SUMMARY OF CHANGES TO ITS SECTION 3.0 - REVISION D

JAFNPP IMPROVED TECHNICAL SPECIFICATION (ITS)

Section 3.0

LIMITING CONDITION FOR OPERATION (LCO) APPLICABILITY SURVEILLANCE REQUIREMENT (SR) APPLICABILITY

INSERT B 3.0-3

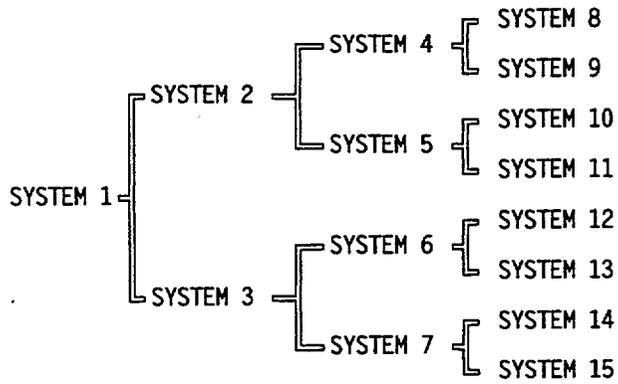
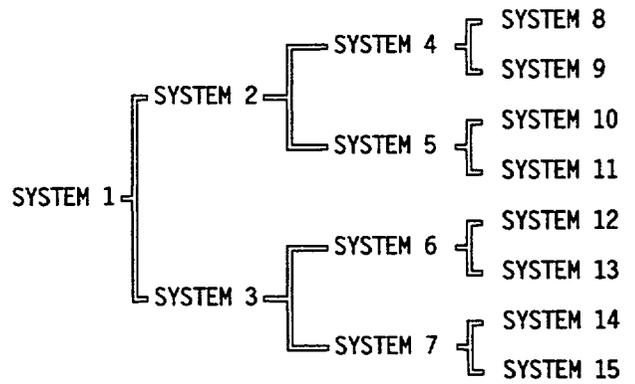
INSERT B 3.0-6

TSTF - 273
